SERVICE LETTER

No. 718

Subject: Bendix Magneto Bulletin No. 566 -- reference attached Avco Lycoming Service Bulletin No. 373, dated March 22, 1974.

SUBJECT: S-1200 Distributor Block and Gear Change

Figure 1.

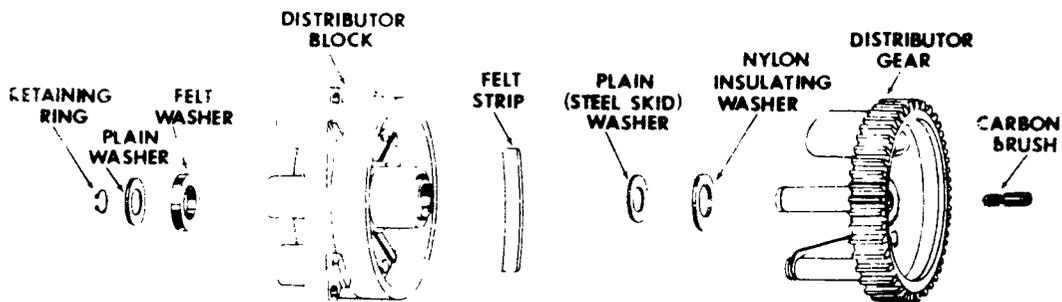
Detailed Instructions:
It has been found that the addition of a nylon insulating washer and steel skid washer between the distributor gear electrode and the block bushing, as shown in figure 1, reduces the possibility of deterioration of the lubricant and possible seizure of the parts.

The addition of the washers make it necessary to shorten the gear end of the bushing and block. New production blocks incorporating the change are identified by a raised

Assemble large distributor gear, nylon and steel washers to new or reworked block as follows using figure 1 as a guide.

2. Slide nylon insulating washer 10-391309 and plain washer 10-391511 onto gear shaft.

3. Lubricate inside of bronze bushing with a light film of Bendix Distributor Block Lubricant. ** Insert shaft of gear through distributor block and position plain washer on shaft. Using the 11-3071 Retaining Ring Pliers, install retaining ring on shaft. Rotate gear to insure there is no interference between gear electrode and block electrodes.

Once modified, the distributor block can be used only with a gear having the nylon and steel washer installed over the shaft as shown in figure 1.

Figure 2

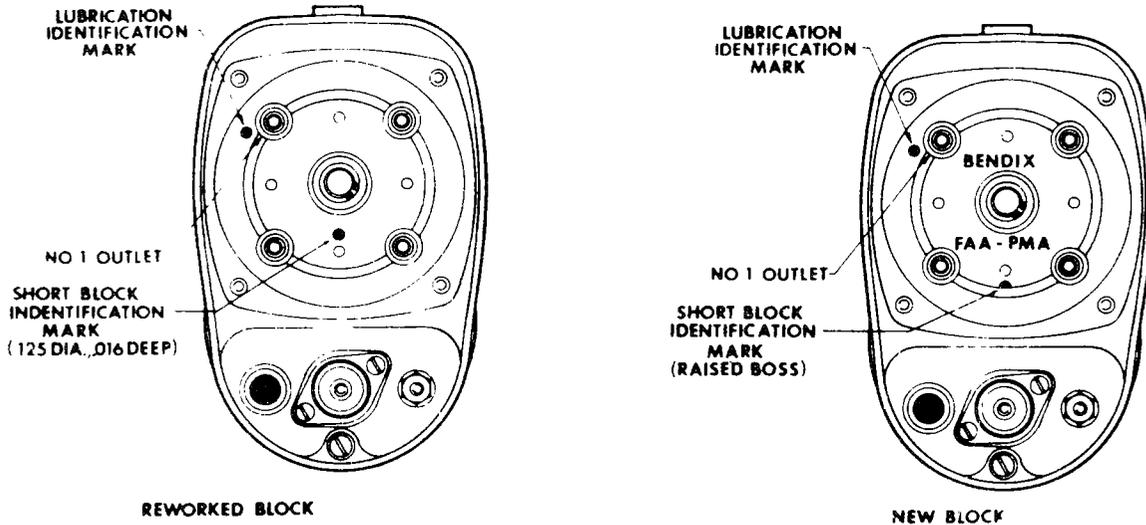
boss between the high tension towers at the six o'clock position and molded in letters as shown in figure 2. Reworked blocks are identified by a drill point indentation in the same location. New and reworked blocks both have different part numbers from the current (old) block. See Table 1.

7. Identify reworked blocks by drilling a flat bottomed hole .125" diameter and .016" deep in the six o'clock position as shown in figure 2.

a. If distributor block is not marked with a raised boss or drill point indentation to the left and adjacent to the No. 1 high tension tower (see figure 2), remove old lubricant from bushing as follows.

(3) Identify distributor block by drilling flat bottomed indentation .125 inch diameter and .016 inch deep located as shown in figure 2.

Figure 3.

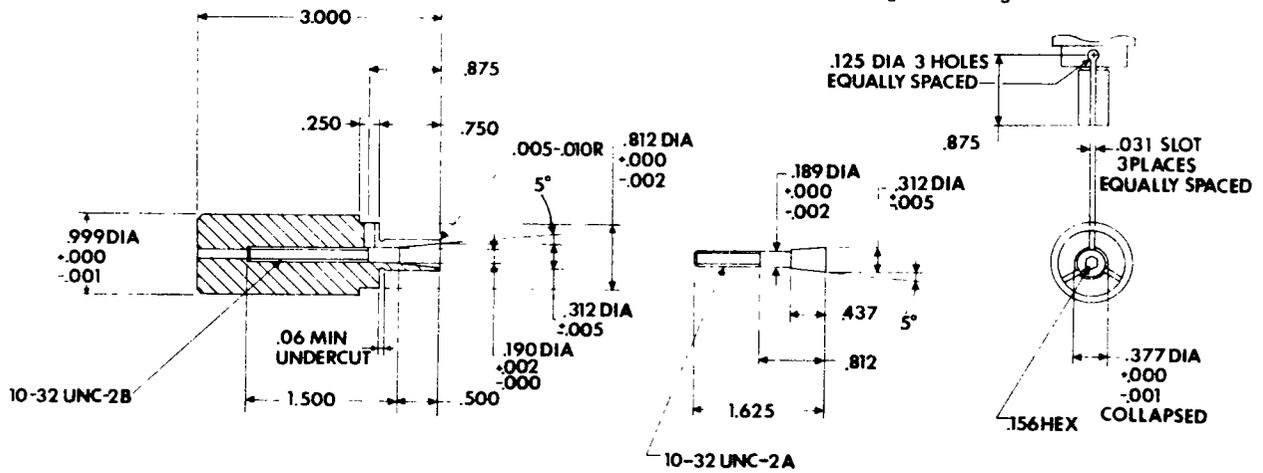
2. Fabricate an expanding arbor lathe fixture as shown in figure 3. (Similar arbors may be purchased from industry machine tool supply houses.)

3. With arbor in lathe, slide distributor block over arbor, high tension outlet tower side first, until block bushing bottoms on arbor shoulder. Tighten arbor expansion screw until block is held securely for turning operation.

Figure 4.

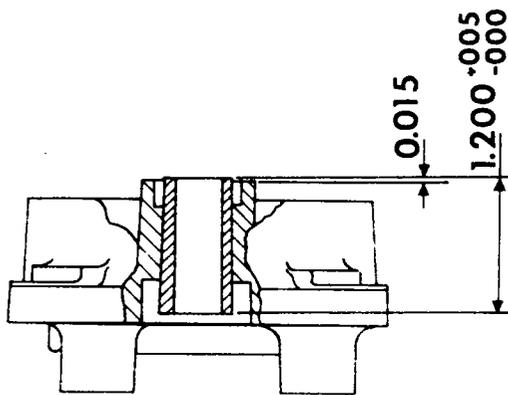
4. Use a suitable cutting tool and turn so that overall length of bushing is $1.200 + .005 - .000$ inch as shown in figure 4. (A Carbaloy tipped tool is recommended.)

5. Using same cutting tool, turn dielectric material of block so that resulting surface is .015 inch below end

of reworked bushing. See figure 4.
